APPENDIX F

Re: Rockville High School – Rock Creek Woods
(Preliminary Plan #1-06010, Site Plan #8-06007)

RE: Preliminary Plan #1-06010
Rock Creek Woods

WSSC Comments on Items for September 12, 2005, Development Review Committee Meeting

Pathway
Alignment

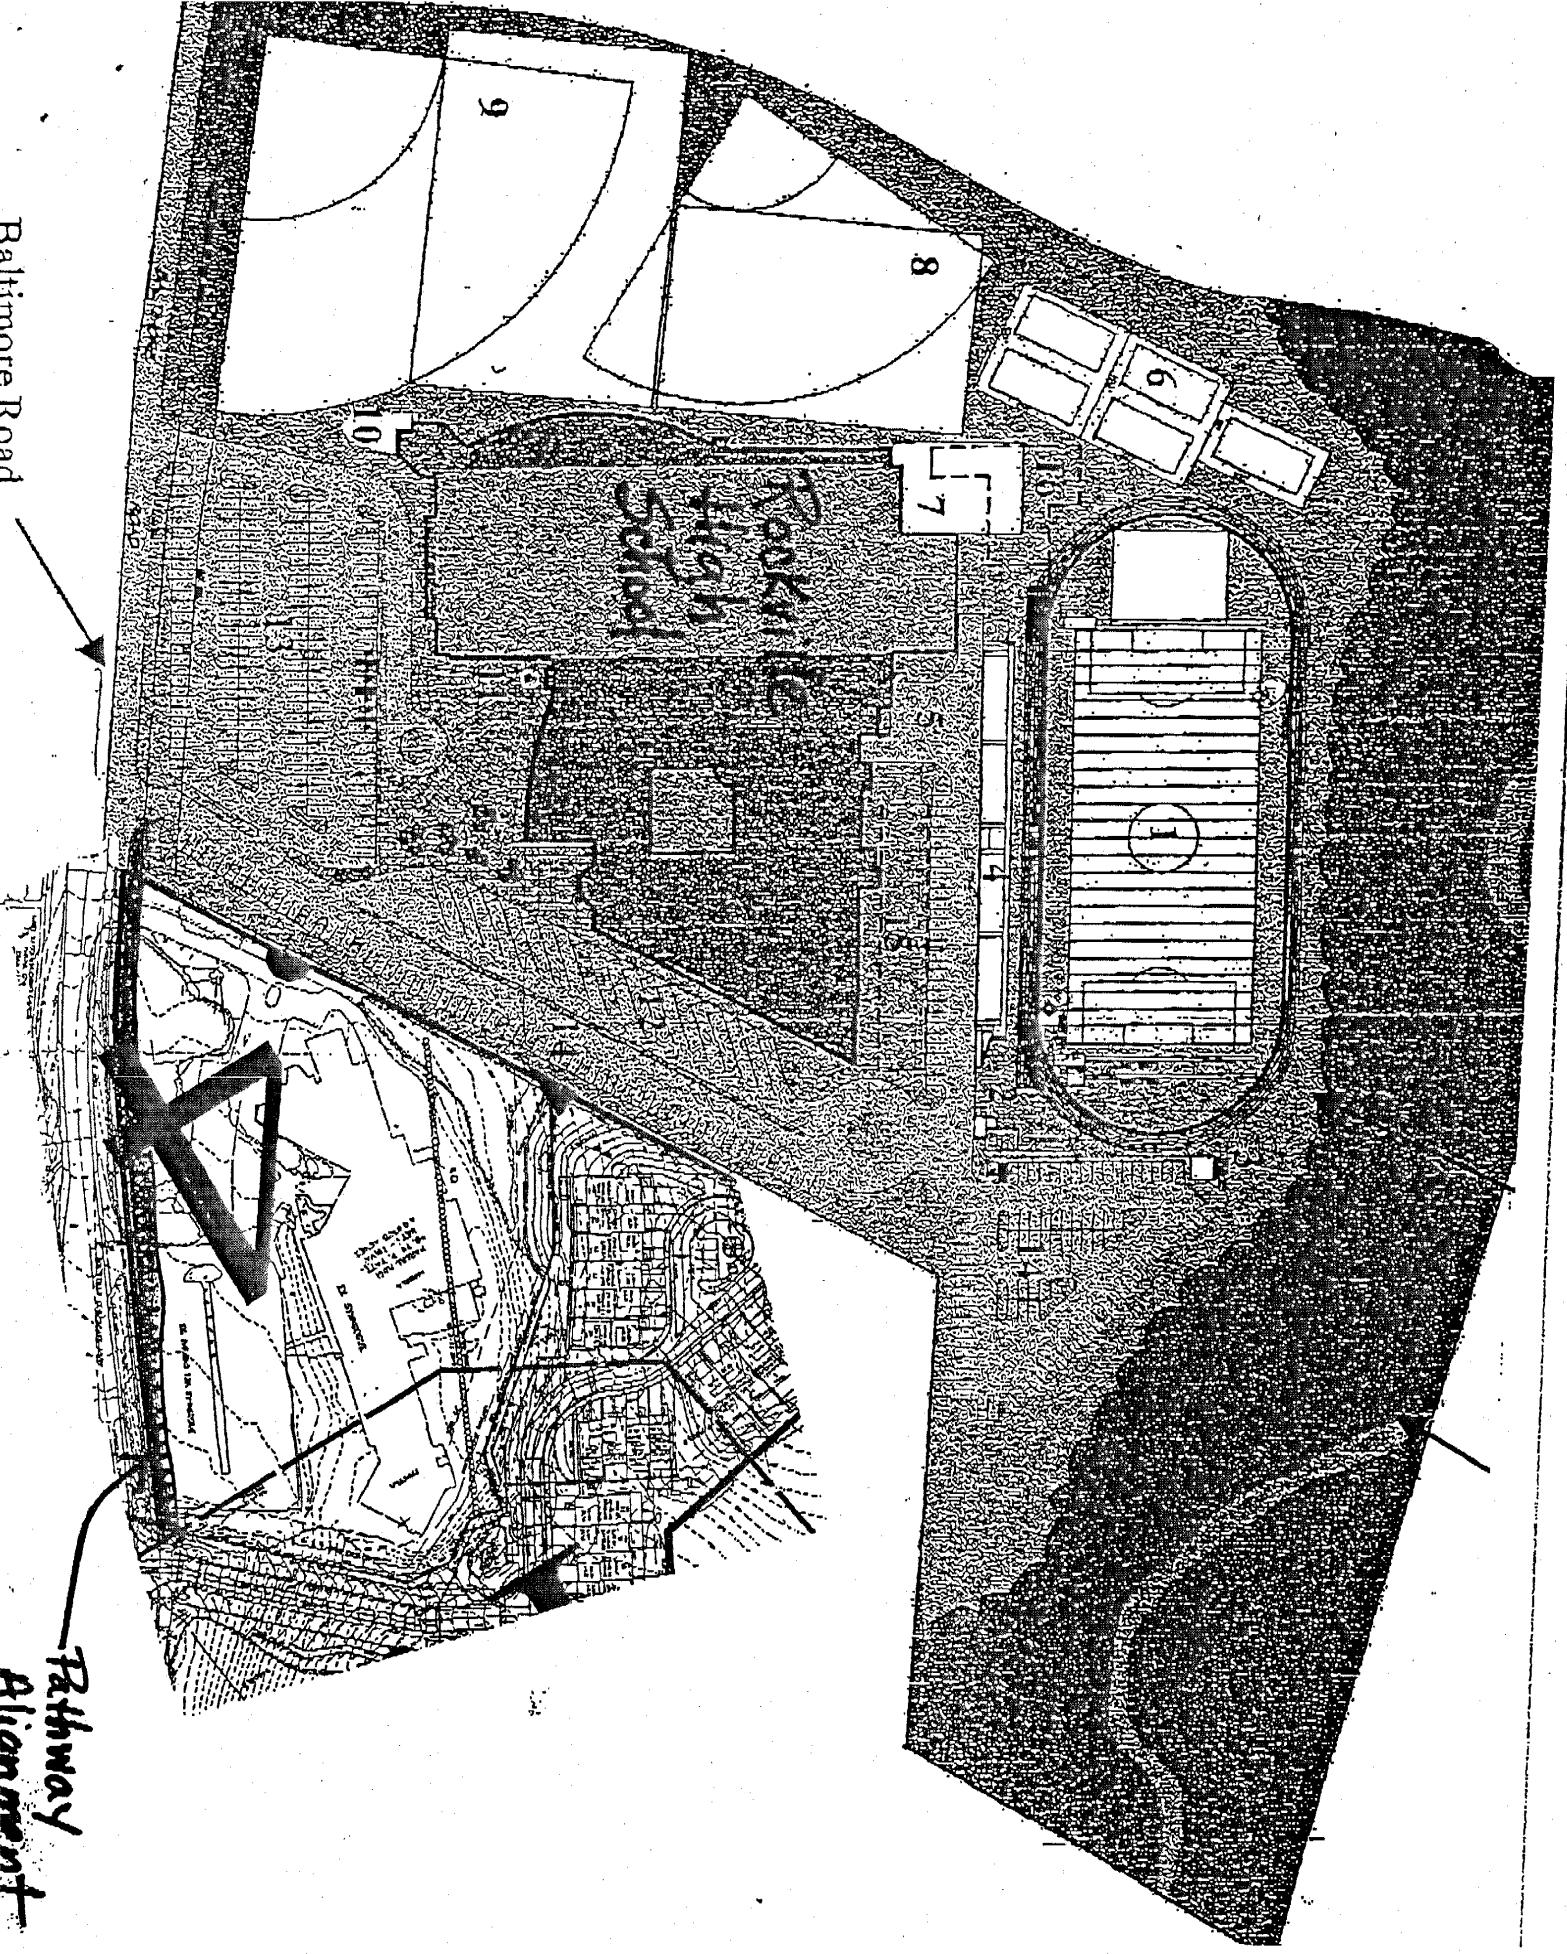
This is to comment on the referenced preliminary and site plans that were presented to the Development Review Committee on September 12, 2005. We request that as a condition of Preliminary and Site Plan approval, the Applicant provide adequate pedestrian connection from the proposed subdivision entrance road to the Rockville High School driveway. Montgomery County Public Schools will grant the necessary right of entry to allow the continuous connection. A drawing is attached that shows the preferred connection highlighted in red.
